UNITED STATES PATENT AND TRADEMARK OFFICE

Office Action Summary

10/540,931

DETAILED ACTION

FIG. 25(C)

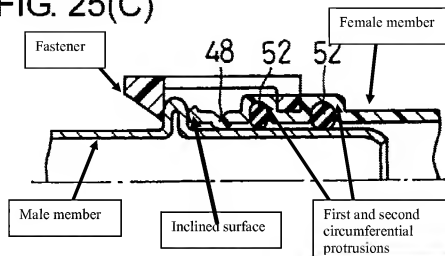
With regard to claim 3, and as shown in Figure 25(C) below, Kawasaki et al disclose a quick connecting device for ducts in motor vehicles, comprising of:

first and second sealing members (52, 52) disposed between said first and second circumferential protrusions, respectively, of said female member and said outer surface of said male member; and

a fastening member disposed around said female and male members so as to be in direct contact with the first circumferential protrusion in a manner that compresses the first sealing member, the fastening member thereby holding said female and male members axially in place.

However, Kawasaki et al do not disclose that the outer surface of the male member has a circumferential groove wherein said male member is receivable in said female member at said first end of said female member without said first end of said female member covering said circumferential groove. However, it is well known in the art to add a bead to a pipe to form a groove or a stop against which a fastener can rest. Kawasaki et al teach, in a different embodiment as shown in Figure 26, that a bead (48) can be formed on the pipe to form a groove between the bead and the upset of the pipe.

With regard to claim 7, and as shown in Figure 25(C) above, Kawasaki et al disclose a quick connecting device for ducts in motor vehicles, comprising of:

a male member having first and second opposite ends, said male member being receivable in said female member at said first end of said female member with said first and second sealing members (52, 52) respectively disposed between said first and second protrusions of said female member and said outer surface of said male member, and

However, Kawasaki et al do not disclose that the outer surface of the male member has a circumferential groove with an inclined surface leading from the circumferential groove wherein the first sealing member is located on the inclined surface and wherein said male member is receivable in said female member at said first end of said female member without said first end of said female member covering said circumferential groove. However, it is well known in the art to add a bead to a pipe to form a groove or a stop against which a fastener can rest. Kawasaki et al teach, in a different embodiment as shown in Figure 26, that a bead (48) can be formed on the pipe to form a groove between the bead and the upset of the pipe. Kawasaki et al also show in Figure 25(C) that there is an inclined surface leading from the circumferential groove (side of upset of male member) where the male and female members can be shortened such that the first sealing member can rest against the inclined surface of the circumferential groove of the male member.
